ENCLOSURE 2

M170085

Draft Responses to the NRC RAIs for the RAJ-II Transportation Package

Figure 3-1.1: CTU-2 Post 9m Impact

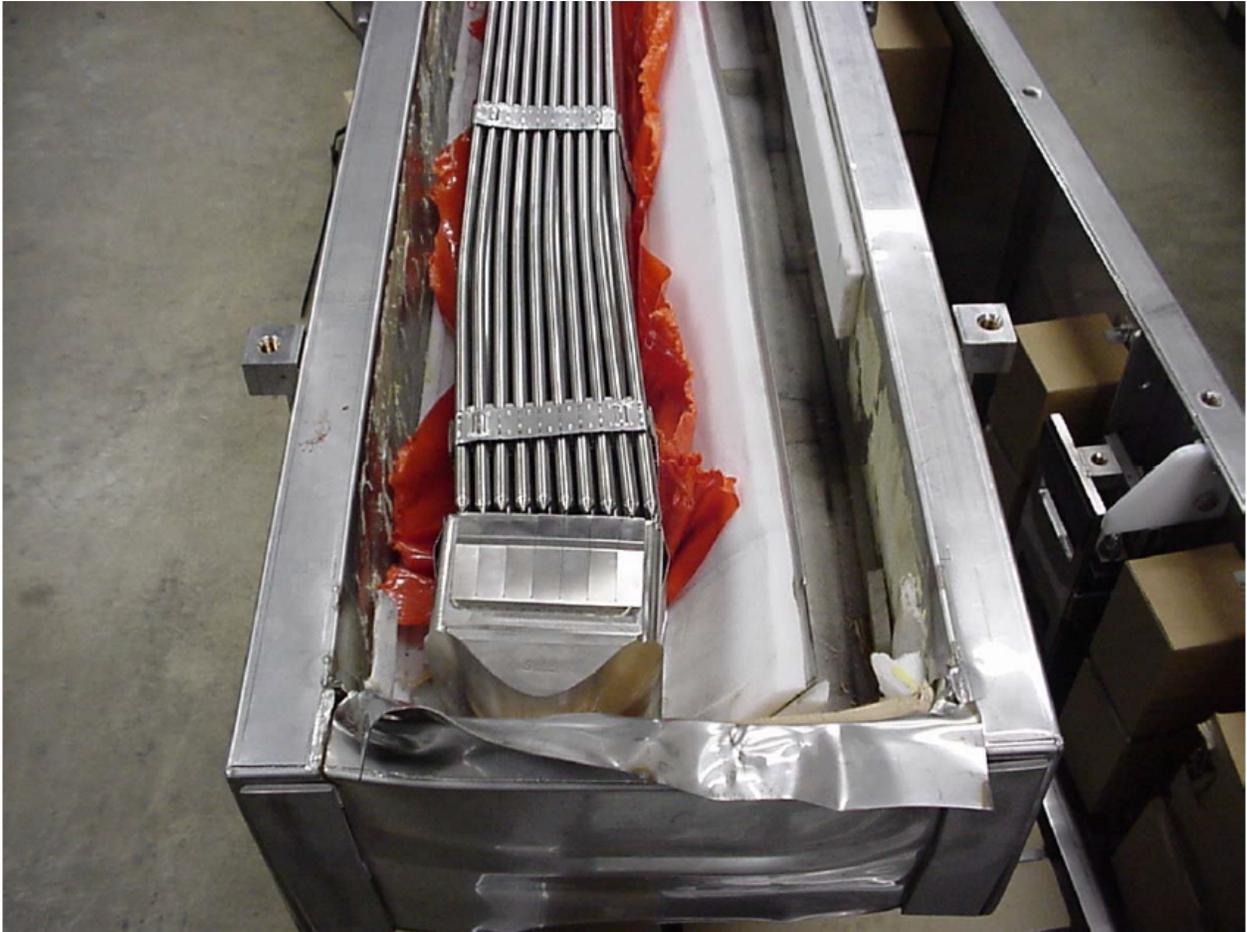
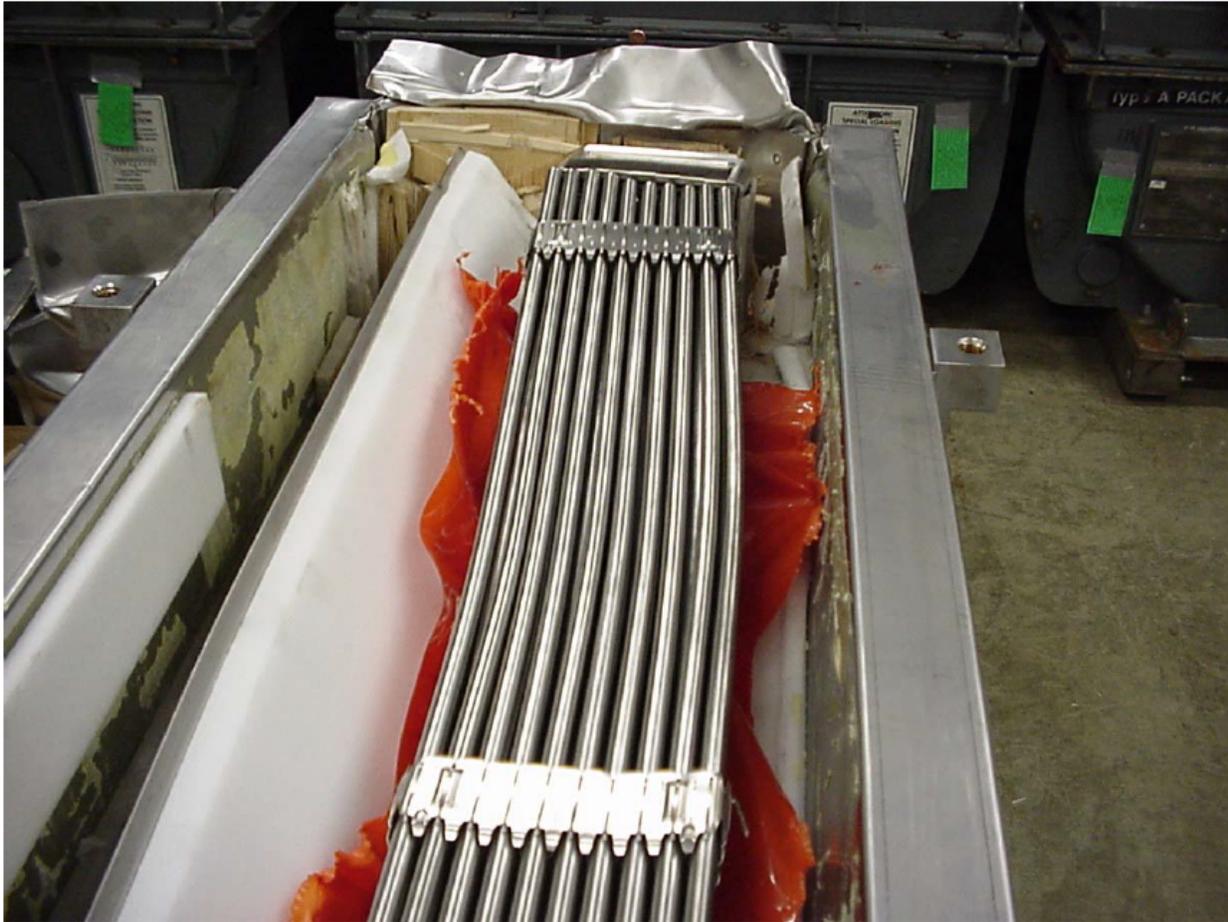
- 3-1 Provide a quantitative analysis to demonstrate that the package, with the cumulative effect of the 10 CFR 71.73 hypothetical accident conditions, would not exceed the regulatory release.

SAR Section 2.7.4 stated that the maximum hypothetical accident condition testing temperature for an earlier-designed fuel assembly was 921 K (1198°F) and that the fuel rod pressure due to accident conditions does not exceed 508 psig (522.7 psia). The SAR also stated that the fuel rods have a rupture pressure in excess of 520 psi (pressure value was not provided). It was not evident that the condition (e.g., strain) of the modified fuel assemblies' deformed fuel rods, after the hypothetical accident condition 30 ft drop (end drop, side drop, etc.) and puncture tests, was quantitatively considered when analyzing at the high temperatures and pressures (e.g., 1198°F and 508 psig) of the thermal hypothetical accident condition and during subsequent calculations that are used for input in the certificate of compliance fuel parameter tables.

Of all the RAJ-II drop test orientations, the 90° end drop test of CTU-2 was the only test article where the fuel rods experienced visible deformation, as described in Table 2-11. For CTU-2, the fuel rods had no significant damage but did experience minimal deformation localized between the lowest two spacers adjacent to the lower tie plate, as shown in Figure 2-41 and 2-43 of Reference 3-1.1, and reproduced in Figure 3-1.1 and Figure 3-1.2 within this response.

Based on the radius of curvature of the most deformed fuel rod, shown in Figure 3-1.1 and Figure 3-1.2 as the rod closest to the exterior of the inner container, the maximum strain at the rod outer diameter, c of 0.202 inch, is estimated to be less than 5% strain. The estimated strain is calculated based on a deflection, y , conservatively assumed as the width of two fuel rods $[[\quad \quad \quad]]$ over an assumed $[[\quad \quad \quad]]$ span length, l . These estimations are taken from the deformation depicted in Figure 3-1.1 and Figure 3-1.2. In reality, the fuel rod

deflection is much less than assumed, and the span length is greater than assumed; therefore, this is a conservative approach in determining the radius of curvature. A deflection of this amount results in a radius of curvature, ρ , of [[]].

Based on Figure 3 of Reference 3-1.2, there is negligible impact on the mechanical performance, strength, and ductility of zirconium alloys for less than 5% strain. Since the plastic strain associated with the 9m impact drop test of the RAJ-II produces less than 5% strain in the fuel cladding, the cold working associated with the impact will not affect the fuel rod thermal performance during the HAC fire event.
